Review of Nestle Waters North America Inc. Water Bottling Project Draft Environmental Impact Report / Environmental Assessment

Tom Myers, PhD
Hydrologic Consultant
Reno, NV
tommyers@gbis.com

McCloud Watershed Council
McCloud, CA.

Figure 2: Hydrograph of flows on Mud Creek. Downloaded from USGS water data website on 8/3/06. The USGS maintained the gage only from 1927 through 1932.

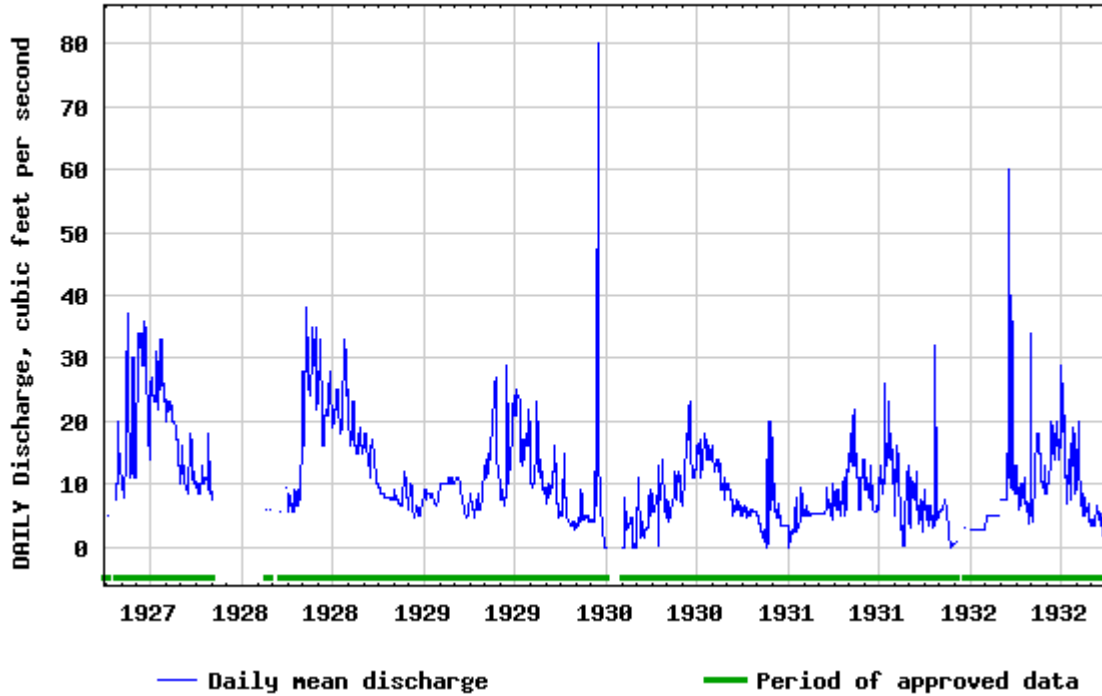
The DEIR/EA assessment of the flow is also wrong because it uses runoff factors to estimate flows rather than considering that spring discharge at discrete locations control the flow rates. The DEIR/EA estimates flow in Squaw Valley Creek and Mud Creek by assuming the runoff factor for the entire McCloud River watershed applies for the two sub-basins. These estimates are not sufficient for detailed impacts analysis because the runoff factor varies according to the exact point of interest in the watershed, primarily the location of the nearest spring. The DEIR/EA, as shown in Table 3.9-10 uses a runoff factor of 0.7, meaning that 0.7 feet for every foot of precipitation above that point is discharge at the point, determined for the McCloud River above Lake McCloud; the average flow rate in the McCloud river watershed was 2.63 cfs/mi². Because of higher precipitation, the DEIR/EA determines that the average flow rate in Squaw Valley Creek (above Hwy 89) and Mud Creek (above Elk Springs) is 3.08 and 3.14 cfs/mi² or 42 and 46 cfs (18,800 and 20,400 gpm), respectively. Compared to the total consumptive use of the project, there appears to be sufficient water. **But this is wrong because stream flows are grossly overestimated.**

Based on the flows at Mud Creek near McCloud (Figure 2), the average monthly flow is 10.8 cfs and average monthly flows range from 2.5 to 28.3 cfs (Table 1), not 46 cfs. The DEIR/EA is wrong in its claim that there is no flow data on Mud Creek as shown by the existence of this gage (DEIR/EA, page 3.9-24). Diverting a substantial portion of Elk Springs could take a substantial amount of flow from Mud Creek¹. If half of the total

1000 gpm of diversion, or 1.1 cfs, comes from Elk Springs, about 10 percent of the average and 45 percent of the lowest monthly flow could be lost from Mud Creek at the former gaging station. Because of the loss rate on the stream, additional stream reaches will go dry during low flow periods.
